Seattle
Design
Commission

APPROVED
MINUTES OF THE MEETING
4 April 2002

Dexter Court

Rainier Beach Library Expansion

Library computer model, looking southwest

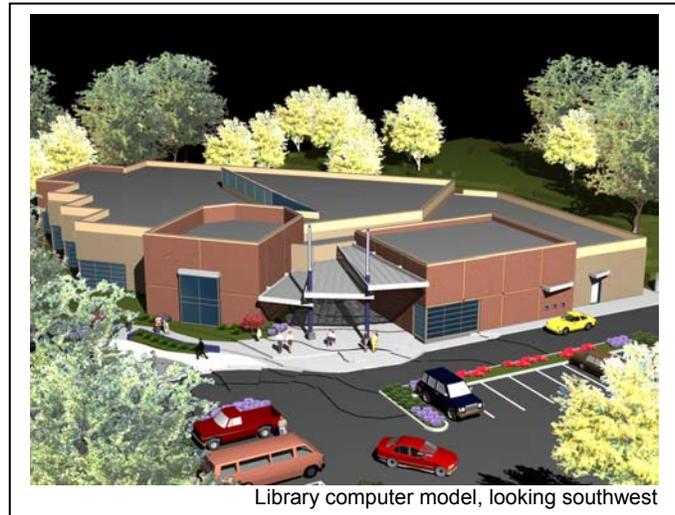
- Recognizes that there are two building masses that frame the entrance to the library, and the mass to the east has a centralized window, while the glazing in the mass to the west turns the corner, and addresses the plaza.

- Suggests that the central window at the children's area could remain, but an additional window, turning the corner, could work as well. Suggests that this could provide an opportunity for "eyes" on the plaza.

- Prefers the contrast between the center window and the corner window. Feels that the façade with the center window has a strong civic presence.
- Would like to know if Rainier Beach is sandy like an ocean beach, or if the beach is more characteristic of a lake beach. Is concerned that this plaza concept is subtle and will not be apparent. Feels that this concept should be obvious.

- Proponents stated that there is a sandy beach at Rainier Beach, and it is going to be restored.
- Encourages further consistency in the architecture of the two building masses framing the entrance plaza. If the center window is preferred, feels that the window at the meeting room should be centered also.

- Proponents stated that the centered window is at the children's area, providing a view of the space to the street. The community strongly supports the design

of the children's area and hopes that it will continue to address the street. Further stated that the mass to the west is the meeting room, and the glazing sets this apart as a different area.

- Proponent stated that the bookshelves along the perimeter of the children's area would be lower, and windows could be located along the corner. Further stated that the horizontal bands are very strong on the façade of the existing building, and some of the design decisions respond to a desire to reduce the horizontality of the façade. The central window maintains the internal axis and the view to the street.
